DEVELOPMENT REVIEW BOARD
SUPPLEMENTAL SUBMITTAL

PROJECT NO. PR-2020-004820

Re: Hotel Circle Ramada Apartment Conversion DRB Comment Responses (PR-2020-004820)

Re: Sidewalk Width Waiver for Apartment Conversion at 25 Hotel Circle NE

SHEET TITLE
SITE UTILITY PLAN

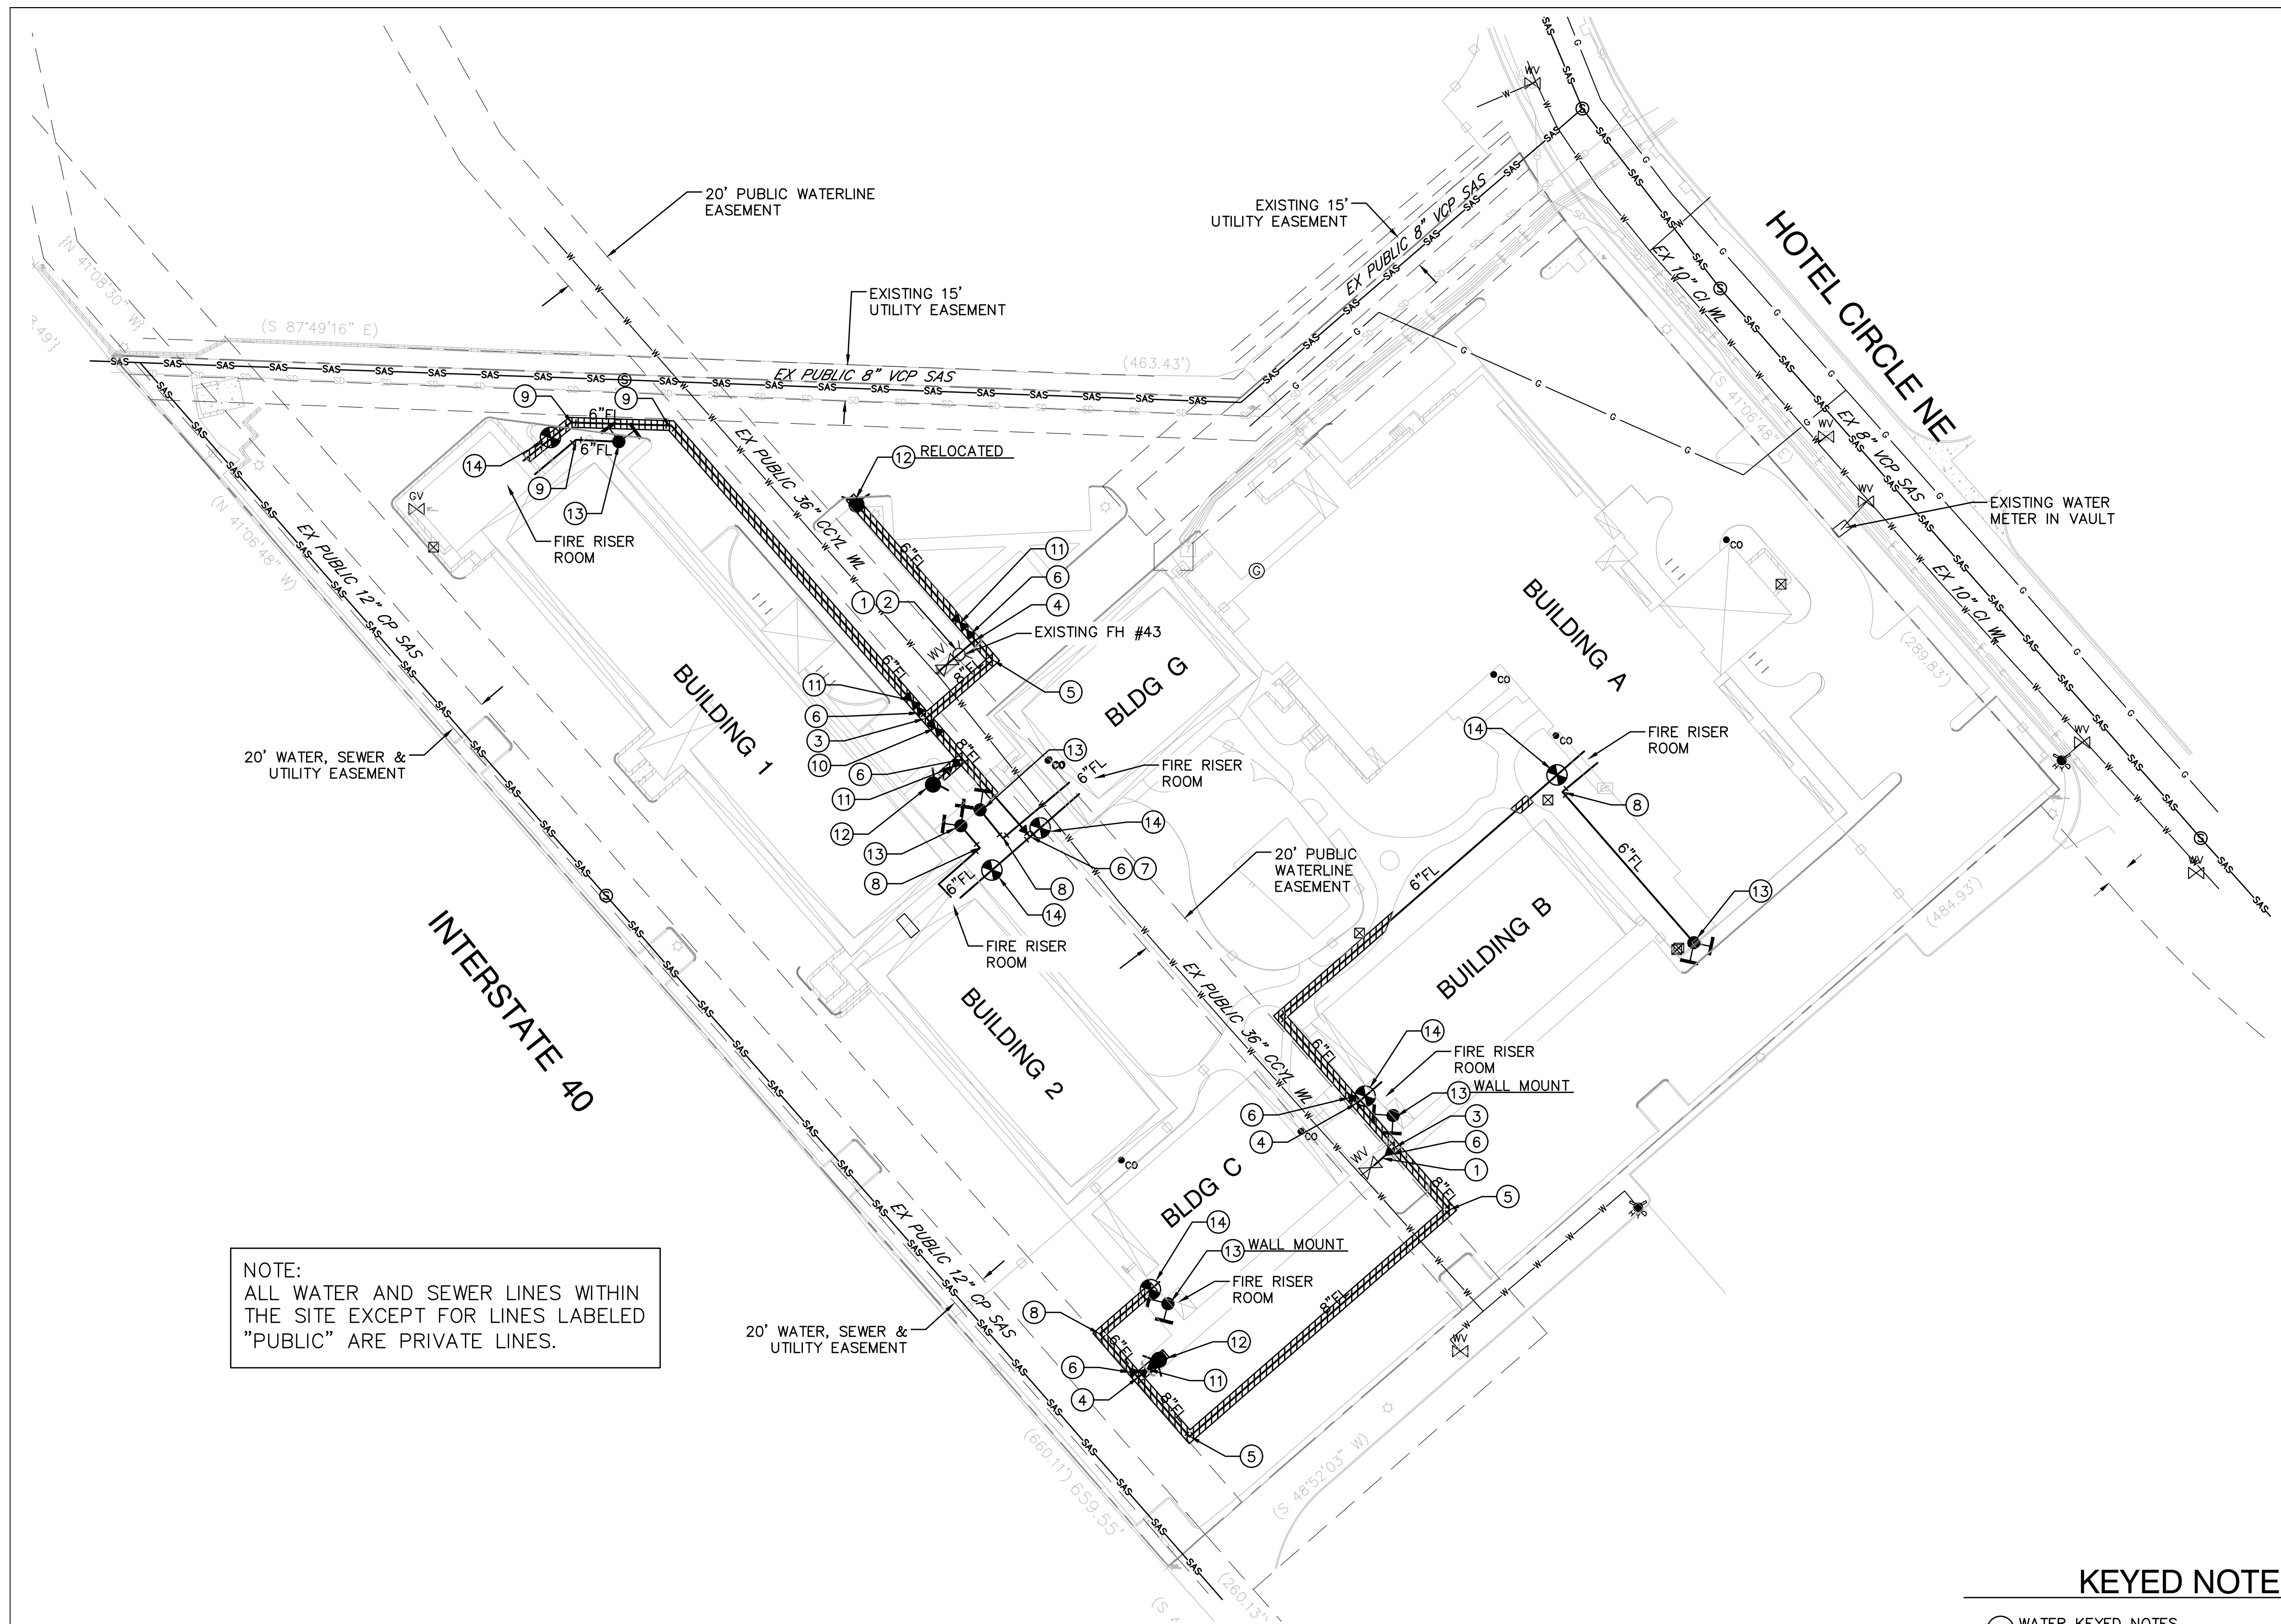
PREVIOUS COMMENT: Please show existing onsite public waterline and sanitary sewer. The utility plan does not show the existing sanitary sewer along the western property line.

The meter to be used is not shown.

Label buildings.

- a. *The plans have been updated accordingly.***

EXISTING TREE CALIPER

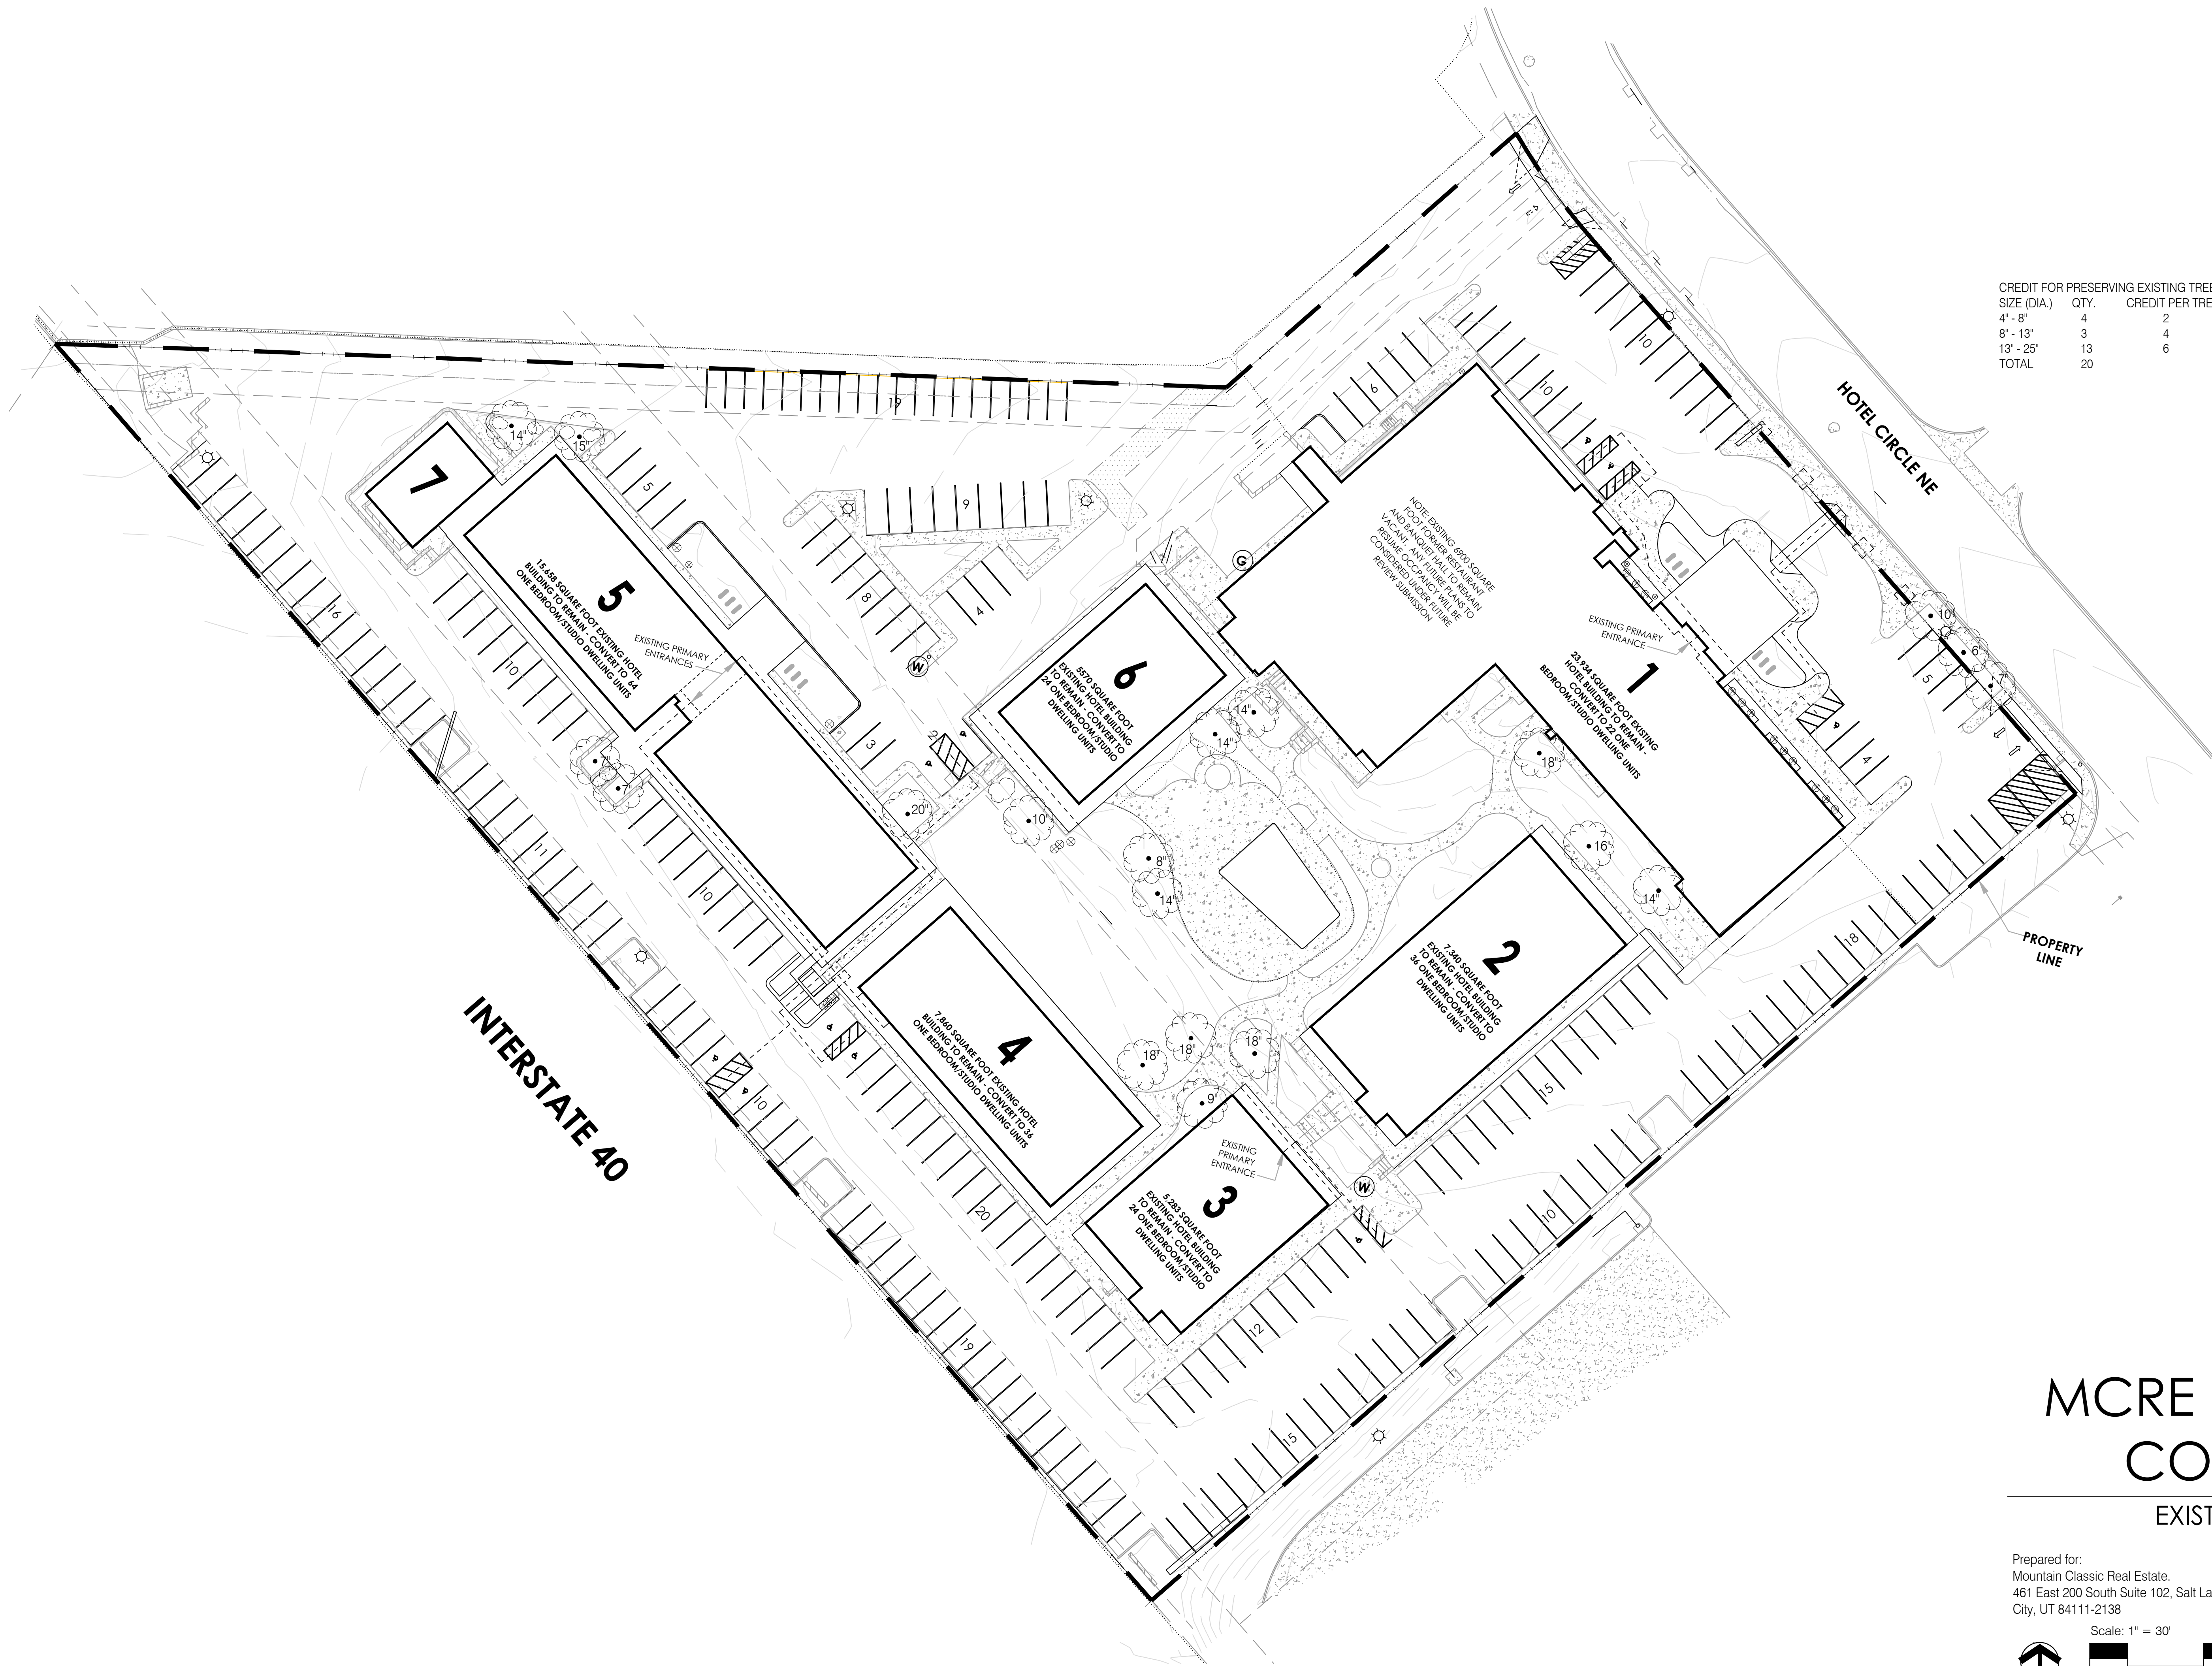
restaurant? The Existing Tree Caliper exhibit indicates the restaurant to remain. Please confirm.

- a. *The easements have been updated on the Site Plan to identify the specifics of each one with widths. All sheets and exhibits have been updated to reflect the intent not to use the restaurant space, which will remain vacant or utilized for common apartment purposes. If the restaurant or another use were to begin operation again, an amendment to the plan to reflect the change of use and impacts to parking would be required and additional services could be determined at that time.***
4. Utility Plan
